SNOHOMISH COUNTY DEPARTMENT OF PUBLIC WORKS	CHANGE ORDER	CHANGE ORDER NUMBER
		4
		2/10/2022
		Page 1 of 7

☐ORDERED BY ENGINEER UNDER SECTION 1-04.4 OF THE STANDARD SPECIFICATIONS. ☒CHANGE PROPOSED BY CONTRACTOR.	**PROJECT IDENTIFICATION** **PROJECT NAME:** Index-Galena Road Flood Repair, MP 6.4-6.9 **PROJECT NUMBER:** RC 1532, RC 1774, RR6322, ER-0701(063)
CONTRACTOR ENDORSEMENT: Dennis Diteman Digitally signed by Dennis Diteman DN: C=US, E=dennisd@goodfellowbros.com, O=Goodfellow Bros, OU=Project Manager, CN=Dennis Diteman Date: 2022.03.21 14:43:34-07'00' *SIGNATURE* *DATE* Dennis Diteman, Project Manager *PRINT NAME* *TITLE*	**CONTRACTOR:** Goodfellow Bros., LLC **ADDRESS:** PO Box 598 Wenatchee, WA 98807

This change order deletes Bid Item No. 24, Temporary Work Access – AC5 as a Value Engineering Change Proposal (VECP). Deleting this bid item of work has an associated reduction in access road restoration items and temporary erosion control items associated with this VECP. The total savings from this deleted work is $126,821.

INDEX–GALENA ROAD
FLOOD REPAIR M.P. 6.4 – 6.9
MITIGATION/PLANTING PLAN

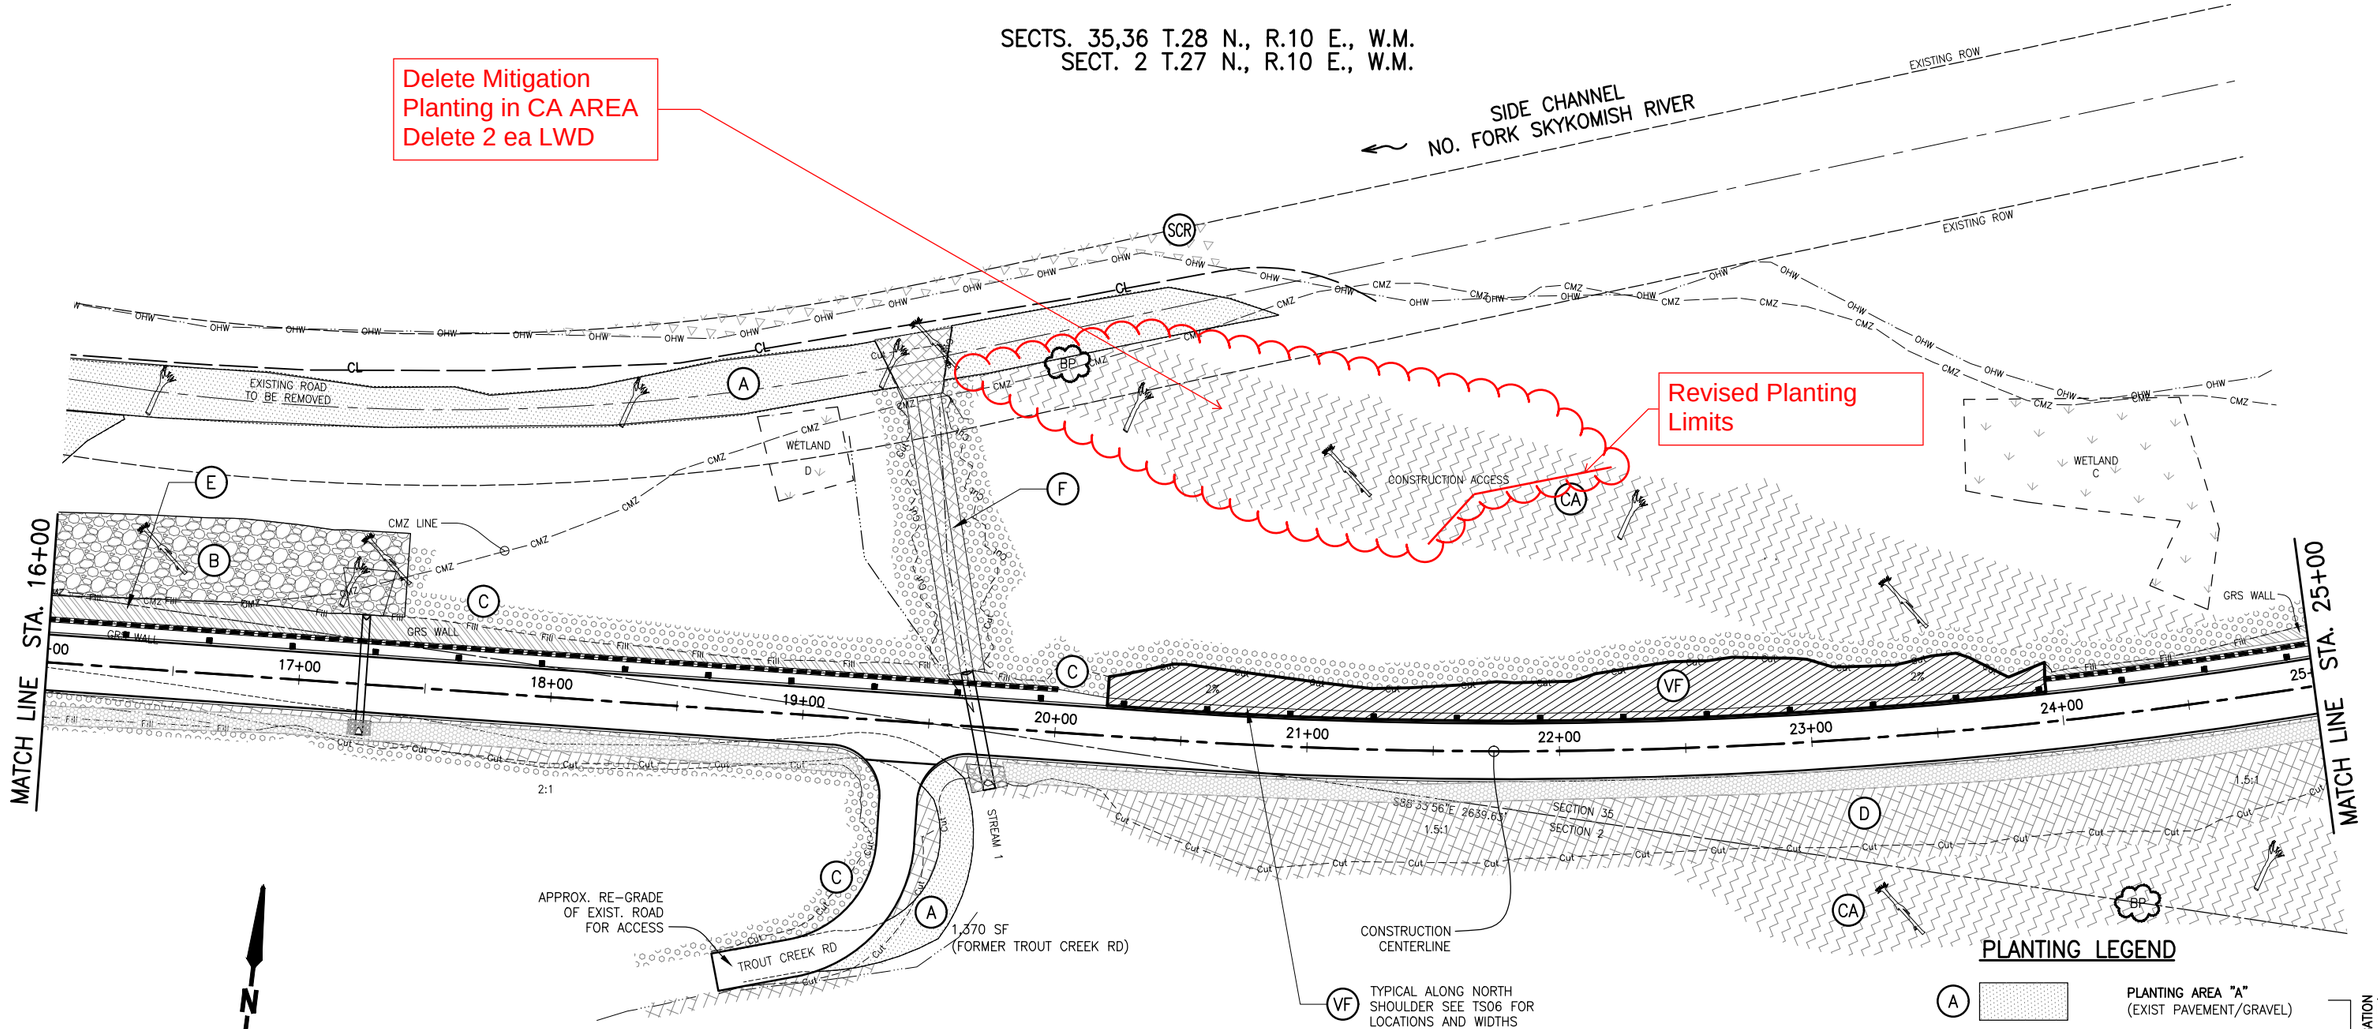
Delete Mitigation Planting in CA AREA
Delete 2 ea LWD

Revised Planting Limits
